**MITSUBISHI HEAVY INDUSTRIES, LTD.**  
16-5, KONAN 2-CHOME, MINATO-KU  
TOKYO, JAPAN

**Subject: MHI's 4<sup>th</sup> Response to NRC's Requests for Additional Information on US-APWR Topical Report: Non-LOCA Methodology, MUAP-07010-P**

**UAP-HF-09040  
Docket No. 52-021**

**MHI's 4<sup>th</sup> Response to NRC's Requests for Additional Information on  
US-APWR Topical Report: Non-LOCA Methodology, MUAP-07010-P**

Figure 5.3-1-3.1 Nuclear Power versus Time – RCCA Ejection (EOC HZP)

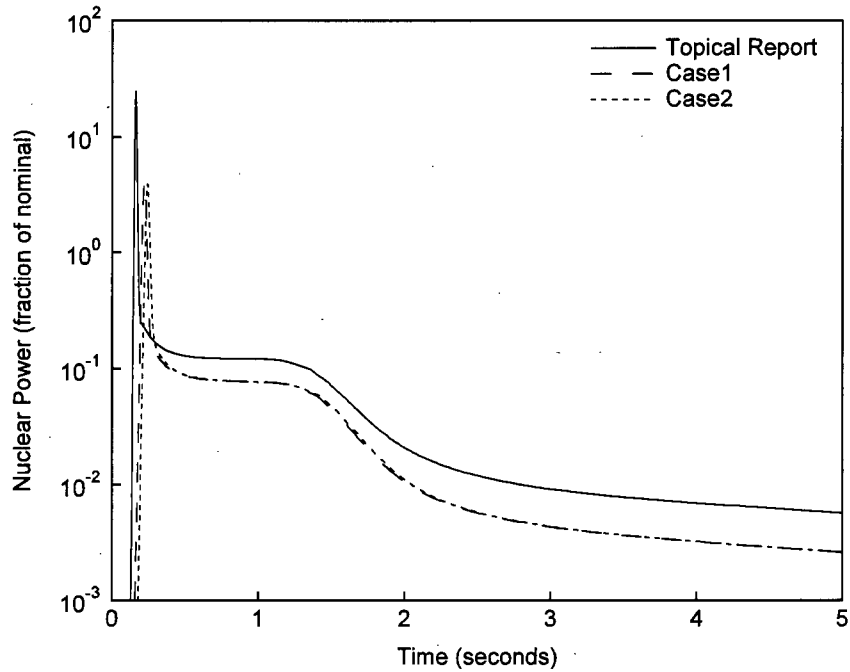
The adjustment is done by "changing the eigenvalue" in both the three- and one dimensional models. In the former, this would mean that a multiplier is applied to the fission rate throughout the reactor rather than to a local property of the controlled fuel assembly (e.g., absorption cross section). What is the impact on the analysis of this approximation?

For the RCCA ejection analysis, there are two methods to add reactivity to the core. One method is to change the eigenvalue, which modifies the fission rate in all regions of the core. The second method is to decrease the local absorption cross section in the assembly where the RCCA is being ejected. While these two methods seem very different, the end results for the RCCA ejection analysis are similar. To show evidence that the results are similar, MHI is providing a sensitivity study comparing the following two cases:

The sequence of events for the sensitivity study is shown in Table 5.3-1-3.1 below. The results of the sensitivity study for the nuclear power and the fuel enthalpy as a function of time are shown in Figures 5.3-1-3.1 and 5.3-1-3.2, respectively. As the figures show, the two methods give very similar results. The hot spot peak fuel enthalpy is 77.8 cal/g for the topical report analysis, 51.1 cal/g for Case 1, and 50.9 cal/g for Case 2. The general shape of the two results is also similar to the topical report results, although the absolute values are different due to the difference in total reactivity insertion (600 pcm for the sensitivities vs. 800 pcm for the topical report). In addition, Figure 5.3-1-3.3 shows the radial enthalpy distributions for both cases<sup>\*1</sup>. These results show that the two methods give similar results and it is therefore acceptable to use the method of "changing the eigenvalue" in the R/E analysis.
